Report: TAB Report
Function: Test, Adjust, & Balance
Date: 06/17/2025
Completed By: National TAB

PROJECT
05-19-25 CHILI'S OLDSMAR, FL

Summary

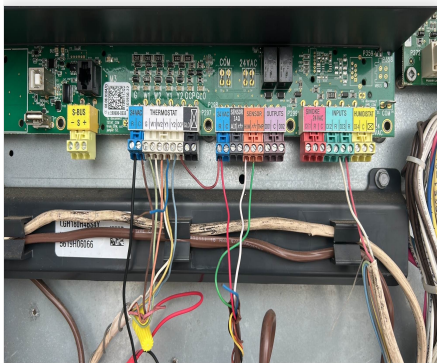
Issue Name : EF-5 Pulley
Description : EF-4 has a broken motor pulley. Unit is still operating bur recommend replacing pulley as quickly as possible.
Created By : National TAB **Assigned To :** National TAB - Kristopher Passley
Status : Open
Priority : Urgent **Asset Tag :**
Originated Date : 06/24/2025 - Kristopher Passley - National TAB

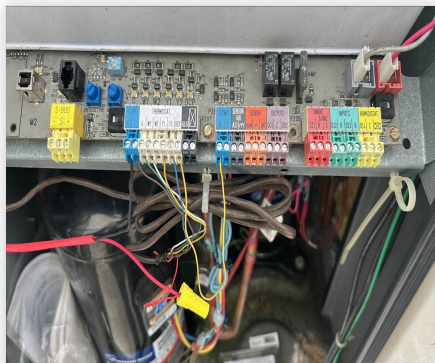
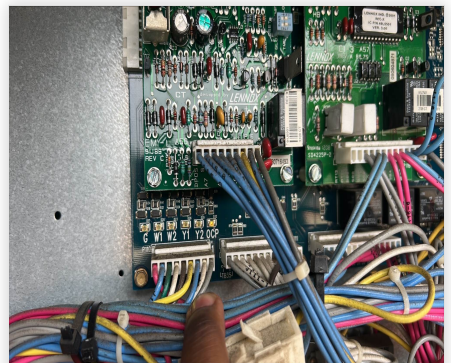
Issue Name : Humidity Control
Description : RTU-1, RTU-2, and RTU-4 do not have their humidity sensors wired. This is causing the diffusers to sweat inside the building. Recommend wiring the humidity sensor using shielded wires for accurate readings.
Created By : National TAB **Assigned To :** National TAB - Kristopher Passley
Status : Open
Priority : Urgent **Asset Tag :**
Originated Date : 06/03/2025 - Kristopher Passley - National TAB

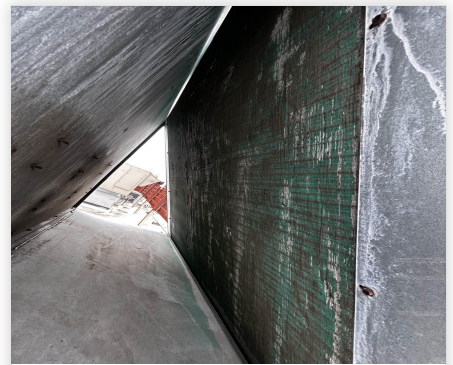
Issue Name : Unit Condenser and Evaporator Coils
Description : Recommend cleaning all RTU condenser and evaporator coils to increase the units efficiency. Some coils are not straight recommend servicing.
Created By : National TAB **Assigned To :** National TAB - Kristopher Passley
Status : Open
Priority : High **Asset Tag :**
Originated Date : 06/03/2025 - Kristopher Passley - National TAB
